SUBJECT: PUBLIC MEETING SUMMARY ON THE REACTOR OVERSIGHT
PROCESS HELD ON SEPTEMBER 19, 2007

On September 19, 2007, the staff hosted the monthly Reactor Oversight Process (ROP) Working Group public meeting. The attendance list for the meeting is contained in Enclosure 1. The agenda for the meeting is contained in Enclosure 2.

Figure 2.2-1 High Head Safety Injection System

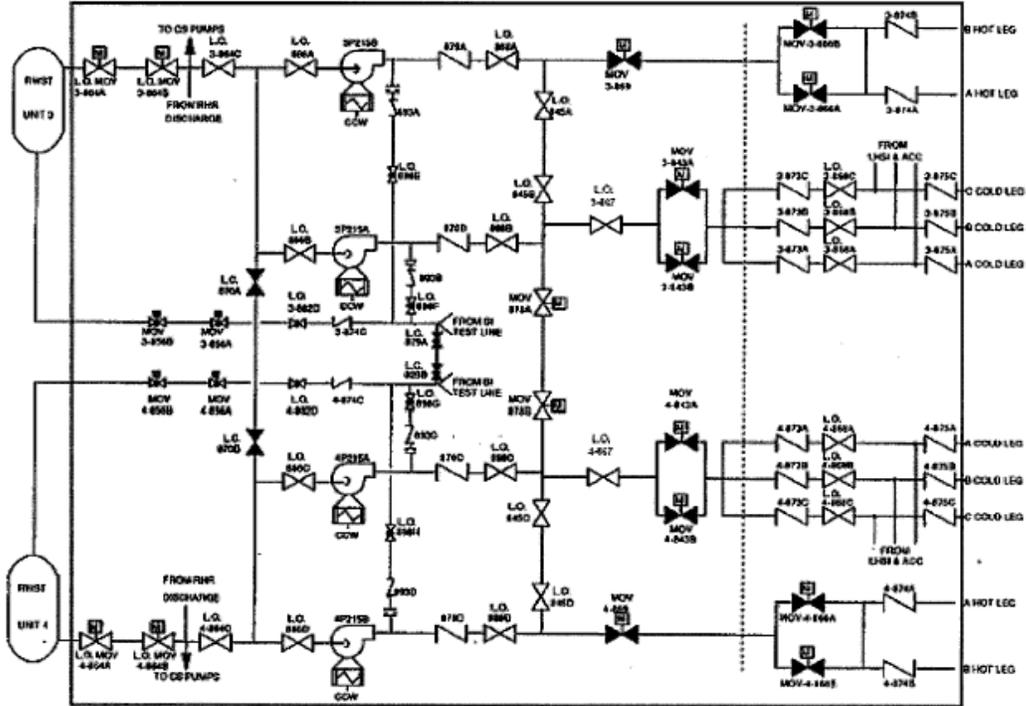
During the week of June 4-8, 2007, an audit of the PTN MSPI programs was conducted. During his review of the PTN MSPI Basis Document proposed update, the technical expert brought in for the audit noted the uniqueness of Turkey Point's HHSI system in that both the Unit 3 and Unit 4 HHSI pumps start on an SI signal from either unit, and all of them feed the stricken unit. He also noted that the generic CCF factors for Turkey Point (NEI 99-02, Table 3) imply that there are 4 pumps being monitored for each unit. The NEI 99-02 guidance for Westinghouse 3-loop plants (pages F-48 and 49), which states that 3-loop plants have 3 pumps, one of which is an installed spare, does not apply for the Turkey Point 3-loop configuration.

For reliability monitoring, the two Unit 3 HHSI pumps are monitored for Unit 3, and the two Unit 4 HHSI pumps are monitored for Unit 4. For unavailability monitoring, the two Unit 3 HHSI pump trains and the two Unit 3 discharge valves are monitored for Unit 3, and similarly, the two Unit 4 HHSI pump trains and two Unit 4 discharge valves are monitored for Unit 4. The opposite-unit pump trains are not monitored for unavailability for either unit. The technical expert for the audit recommended that the opposite-unit HHSI pumps be added for unavailability and reliability monitoring.

At Turkey Point, each unit (Unit 3 and Unit 4) has two HHSI pumps. The Unit 3 and Unit 4 HHSI pumps start on an SI signal from either unit, and all of them feed the stricken unit. Should the Turkey Point reporting model be revised to address the four train approach?

Resolution: Yes. In order to ensure accurate reporting, add the opposite-unit HHSI pump trains for unavailability monitoring for each unit, and the opposite-unit HHSI pumps for reliability monitoring for each unit. Although the opposite-unit HHSI pumps are cooled by the opposite-unit component cooling water (CCW) pumps, they should not be added as they are already monitored for their associated unit, and their Birnbaum importances for the opposite-unit are several orders of magnitude less than their Birnbaum importances for their own unit.
